NATIONAL FIRE PROTECTION ASSOCIATION

TO: Code-Making Panel 2

SUBJECT: NEC® CMP-2 Second Draft FINAL Ballot Results (A2025)

Figure Informational Note 120.1 Branch-Circuit, Feeder, and Service Load Calculation Methods.

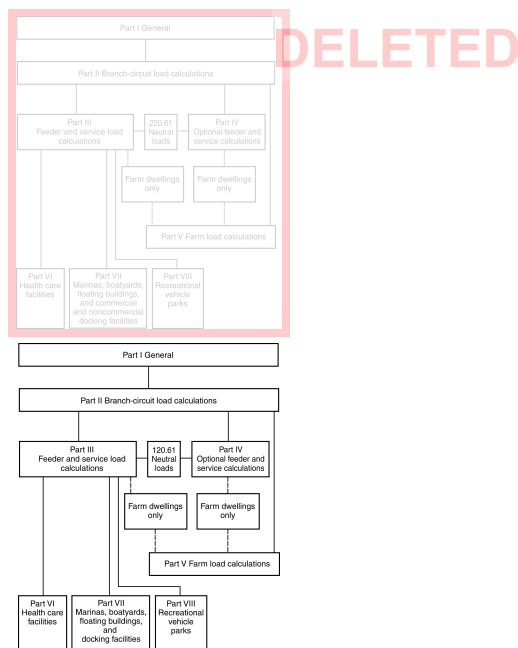
Committee Statement:	The Scope of Article 120 and Figure 120.1 are revised to reflect the correct title for Part VII and the addition of Part VIII.
Response Message:	SR-7777-NFPA 70-2024

FIGURE 308.2.1
UNOBSTRUCTED FORWARD REACH

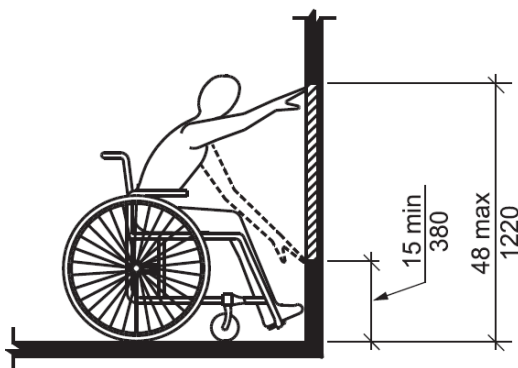
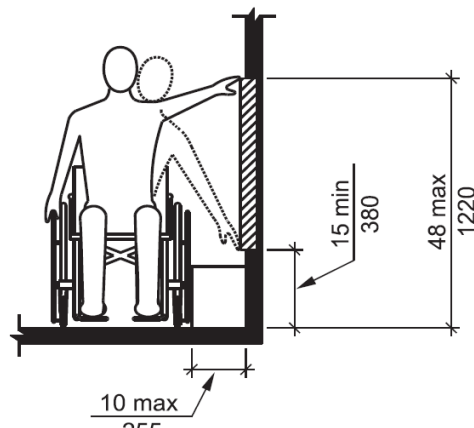
Requiring receptacle outlets to be at least 24 in. below the countertop or work surface places them outside the reach range for accessibility for a standard 36-inch counter height. (See the figures below from A117.1.) Convenience receptacles are currently optional at kitchen islands and peninsulas, but this change effectively prohibits such receptacles in all cases where accessibility and the NEC both apply. Occupants want these receptacles installed, but they will have to be within accessible reach ranges in nearly all multifamily structures.

In addition, receptacles *are required* by the NEC under any bar-type counter that creates wall space (see 210.52(A)(2)(3)). In this case, an irreconcilable conflict between this code and both the building code and federal law will result.

Public comment 1348 suggested a height limitation of no more than 20 inches above the floor to allow for receptacles below counters to meet accessibility requirements, but that change was not approved by CMP-2. The PC was reviewed by the NFPA Disability Access Review Advisory Committee (DARAC: www.nfpa.org/darac), and the committee, by letter ballot, concurred with the technical changes and the substantiation provided. The height of 20 inches above the floor was chosen to allow for a 5-inch dimension where a duplex receptacle can be installed. This is a small area for compliant installation considering construction tolerances and possible material changes.

Figure 210.52(C)(1) Determination of Area Behind a Range, Counter-Mounted Cooking Unit, or Sink.

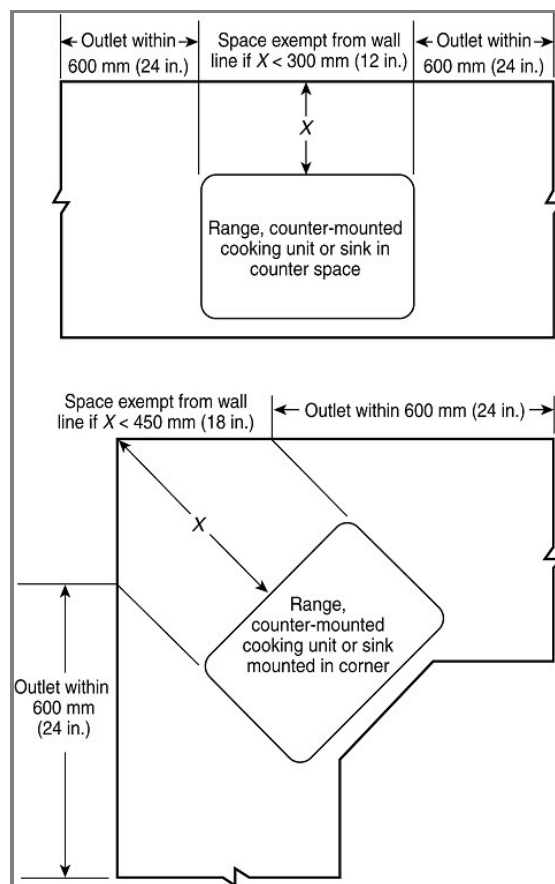
Exception No. 1: Receptacle outlets shall not be required directly behind a range, counter-mounted cooking unit, or sink in the installation described in Figure 210.52(C)(1).

Exception No. 2: Where a required receptacle outlet cannot be installed in the wall areas shown in Figure 210.52(C)(1), the receptacle outlet shall be permitted to be installed as close as practicable to the countertop area to be served. The total number of receptacle outlets serving the countertop shall not be less than the number needed to satisfy 210.52(C)(1). These outlets shall be located in accordance with 210.52(C)(3).

FIGURE 308.2.1
UNOBSTRUCTED FORWARD REACH

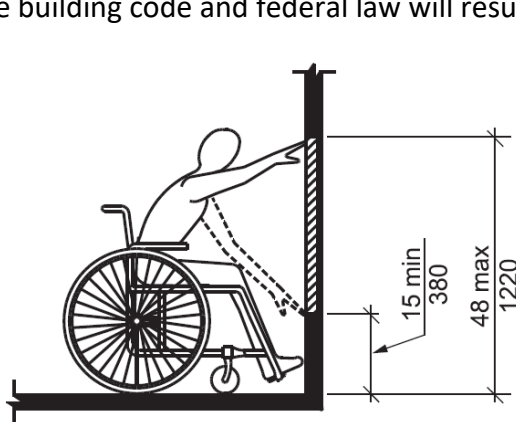
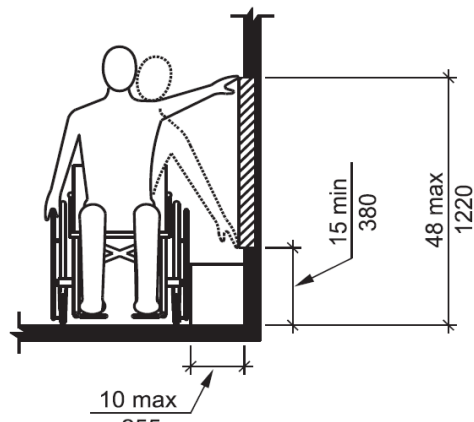
Requiring receptacle outlets to be at least 24 in. below the countertop or work surface places them outside the reach range for accessibility for a standard 36-inch counter height. (See the figures below from A117.1.) Convenience receptacles are currently optional at kitchen islands and peninsulas, but this change effectively prohibits such receptacles in all cases where accessibility and the NEC both apply. Occupants want these receptacles installed, but they will have to be within accessible reach ranges in nearly all multifamily structures.

In addition, receptacles *are required* by the NEC under any bar-type counter that creates wall space (see 210.52(A)(2)(3)). In this case, an irreconcilable conflict between this code and both the building code and federal law will result.

Public comment 1348 suggested a height limitation of no more than 20 inches above the floor to allow for receptacles below counters to meet accessibility requirements, but that change was not approved by CMP-2. The PC was reviewed by the NFPA Disability Access Review Advisory Committee (DARAC: www.nfpa.org/darac), and the committee, by letter ballot, concurred with the technical changes and the substantiation provided. The height of 20 inches above the floor was chosen to allow for a 5-inch dimension where a duplex receptacle can be installed. This is a small area for compliant installation considering construction tolerances and possible material changes.

Figure D.15(a) Monitoring Controlled and Noncontrolled Loads, 50- Amperes EVSE.

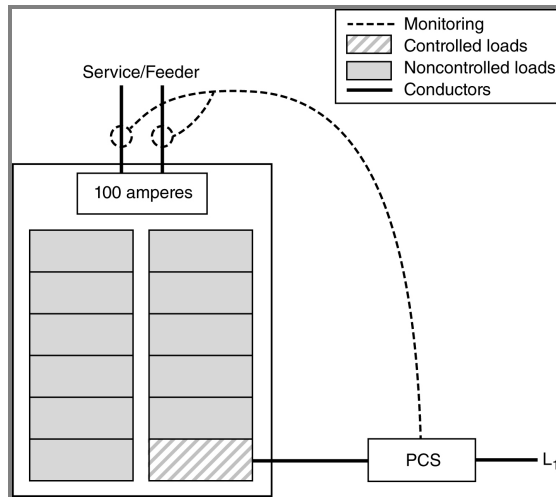
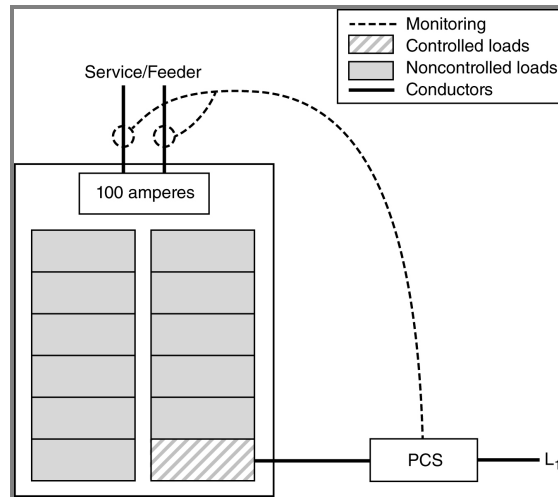
The titles to Examples D15(a) and D15(b) were expanded to provide additional information regarding the content of those examples.

Figure D.15(c) Monitoring Only Controlled Loads, 35 32- Amperes EVSE, 20- Amperes Pool Pump, and 30- Amperes HVAC Heat Pump.

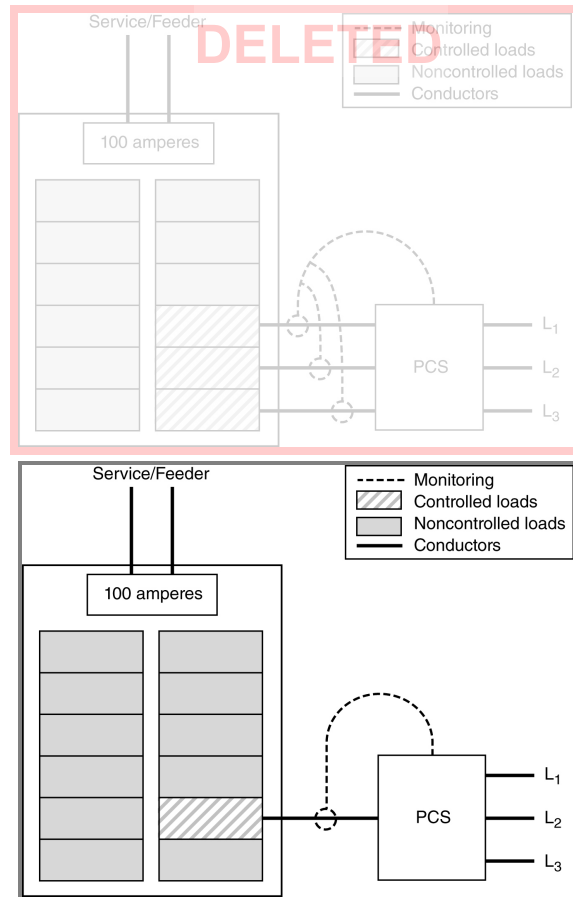
Example D15(c) was incorrect, as it mentioned monitoring all loads, which was not consistent with the drawing. The example was modified to address recommendations in PC 1850 and ensure the drawing and the calculations in the example accurately reflect application of the requirements in 120.7.

Total service load is noncontrolled plus controlled loads = ~~23,040~~ 17,040 volt-amperes (96 71 amperes, 240 volts)
